MACK TRUCKS, INC.
2100 MACK BOULEVARD
P.O. BOX M
ALLENTOWN, PA 18105-5000

SUBJECT: Vehicle Safety Recall - SC0332
Steering Gear Mounting Bolt

SC332

Subject: Steering Gear Mounting Fastener Torque — CXU, CXN and CHU Models

Figure 1 — Steering Gear Mounting Fastener Torque

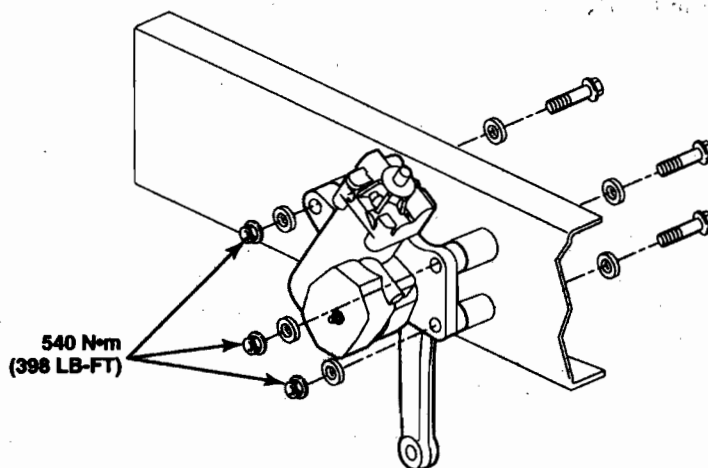
It has been determined that the steering gear mounting fasteners on certain CXU, CXN and CHU model chassis may not have been tightened to proper specifications at assembly, and as a result, steering can be adversely affected. Approximately 1,434 CXU, CXN and CHU model chassis manufactured between July 7, 2007 and September 21, 2007 are involved in this campaign. A list of affected chassis has been sent to all applicable dealers.

Tighten the steering gear mounting fasteners as follows:

- Secure the chassis for service, apply the parking brakes and block the wheels to prevent the vehicle from moving.
- Using an accurately calibrated torque wrench on the mounting nuts (outer) and a wrench on the bolts (inner), tighten the three fasteners to 540 N·m (398 lb-ft).

3. Mark each nut with a yellow paint stick to signify that the fasteners have been torqued to specifications.
